State of New Mexico
Energy, Minerals and Natural Resources
OIL CONSERVATION DIVISION
1220 South St. Francis Dr.
Santa Fe, NM 87505

Form C-103
Revised July 18, 2013

WELL API NO. 30-025-29786
5. Indicate Type of Lease STATE [] FEE [X]
6. State Oil & Gas Lease No.
7. Lease Name or Unit Agreement Name E.B. Anderson
8. Well Number 03
9. OGRID Number 329487
10. Pool name or Wildcat Brown Devonian W.
4. Well Location Unit Letter M : 330 feet from the South line and 330 feet from the West line
Section G Township 13S Range 38E NMPM County Lea
11. Elevation (Show whether DR, RKB, RT, GR, etc.) 3862 GL.

E. B. Anderson Well #3
Sec. 6 T135 R38E
Lea County, NM
API # 30-025-29980

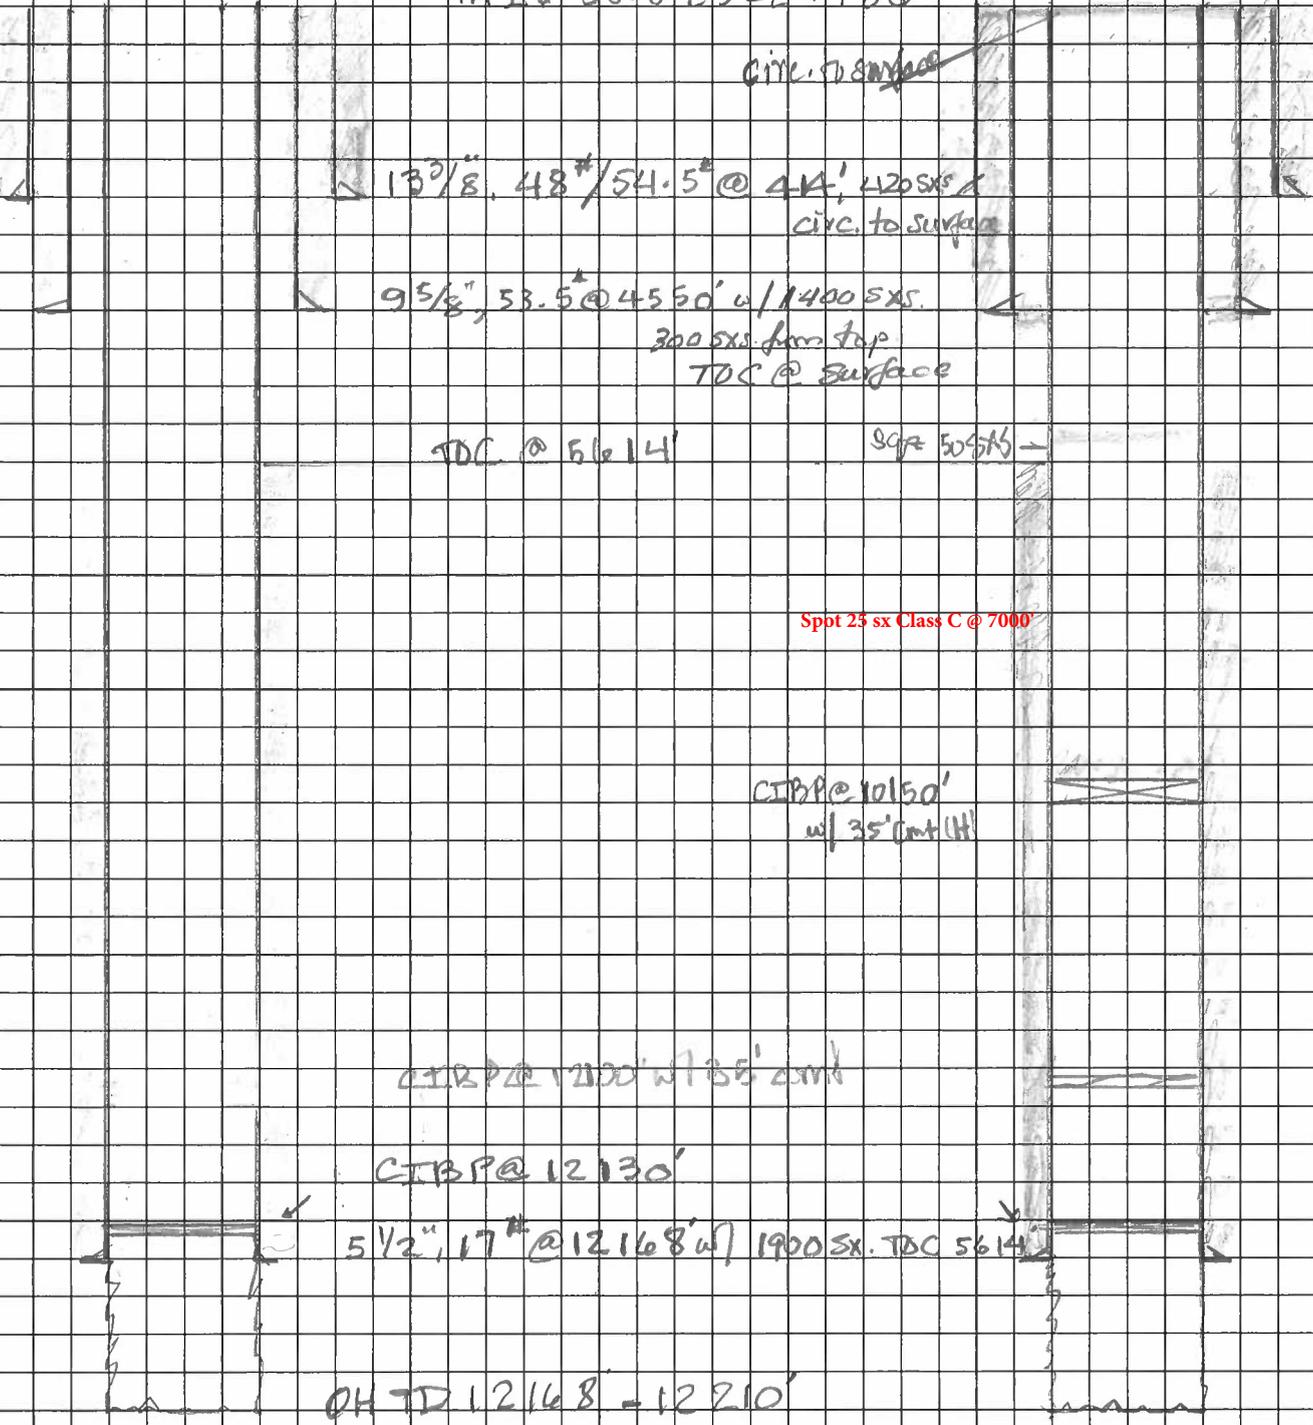
Operator:	P.O. Box 7227	Dallas, TX75209	OGRID:	329487	Action Number:	16453	Action Type:	C-103F
BXP OPERATING, LLC								
OCD Reviewer	Condition							
kfortner	See attached conditions of approval Note changes to procedure

9. Mud laden fluids must be placed between all cement plugs mixed at 25 sacks per 100 bbls of water.
10. All cement plugs will be a minimum of 100' in length or a minimum of 25 sacks of cement, whichever is greater. 50' of calculated cement excess required for inside casing plugs and 100% calculated cement excess required on outside casing plugs.

11. Class 'C' cement will be used above 7500 feet.
12. Class 'H' cement will be used below 7500 feet.
13. A cement plug is required to be set 50' above and 50' below, casing stubs, DV tools, attempted casing cut offs, cement tops outside casing, salt sections and anywhere the casing is perforated, these plugs require a 4 hour WOC and then will be tagged

17. A CIBP is to be set within 100' of production perforations, capped with 100' of cement, WOC 4 hours and tag.
18. A CIBP with 35' of cement may be used in lieu of the 100' plug if set with a bailer. This plug will be placed within 100' of the top perforation, (WOC 4 hrs and tag).
